<b>DOCKETED</b>	
<b>Docket Number:</b>	20-SPPE-01
<b>Project Title:</b>	Great Oaks South Backup Generating Facility Small Power Plant Exemption
<b>TN #:</b>	233681
<b>Document Title:</b>	SV1 Supplemental Responses to CEC Data Requests 18 and 56
<b>Description:</b>	N/A
<b>Filer:</b>	Scott Galati
<b>Organization:</b>	DayZenLLC
<b>Submitter Role:</b>	Applicant Representative
<b>Submission Date:</b>	6/30/2020 10:14:36 AM
<b>Docketed Date:</b>	6/30/2020

# SUPPLEMENTAL RESPONSES TO CEC STAFF DATA REQUEST SET 2 (18 AND 58)

Great Oaks South Backup Generating Facility (19-SPPE-  
03)

1 SV-12 - ROOF PLAN - OVERALL  
1:300

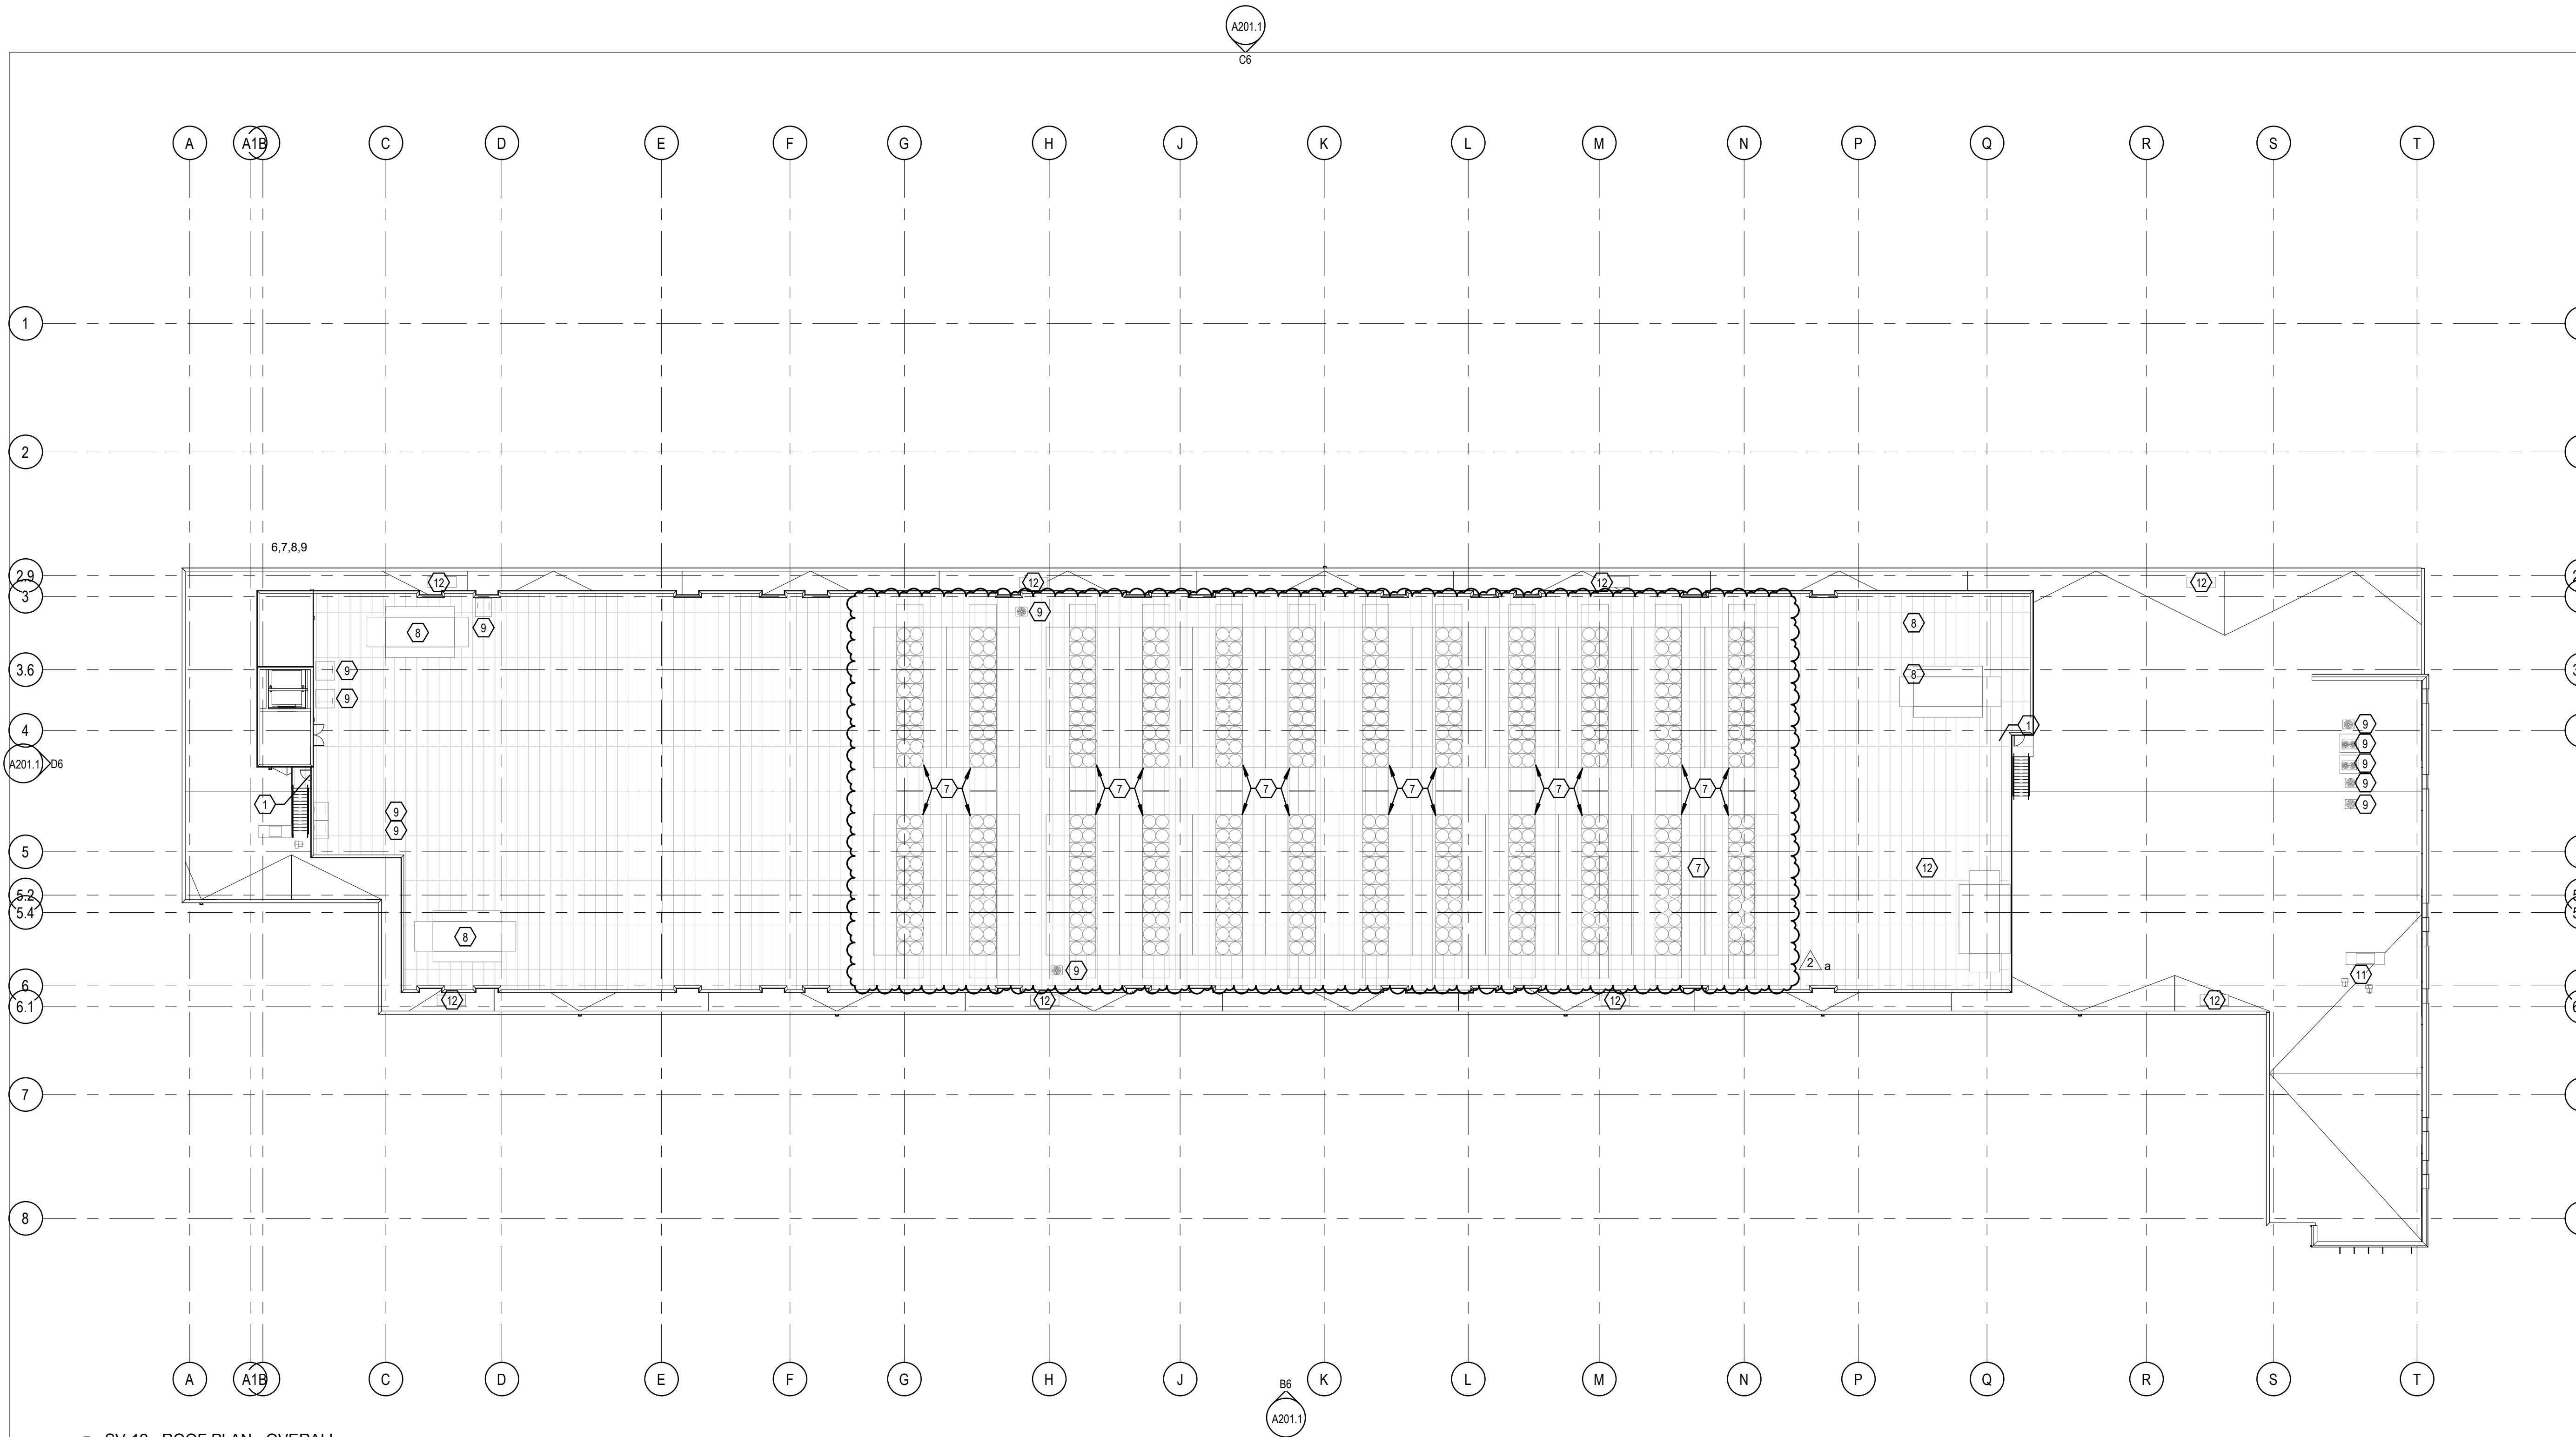
56. Provide detailed explanation why other, less water intensive, cooling technologies have not been considered.

After further research into the recycled water issue, SV1 has made the decision to modify the cooling technology for the Great Oaks South Data Center by replacing the Water-Cooled Chilled Water system with Air-Cooled Chilled Water System with refrigerant-side economizer. The new mechanical system will consist of (72) total 400-ton chillers, (24) per building. Each building's cooling system will operate in a 22+2 redundancy configuration. Attachment UTIL DR-56 includes a modified roofing plan showing the locations of the chillers.

This project modification reduces the total water demand to less than 4 acre feet per year for all three data center buildings.
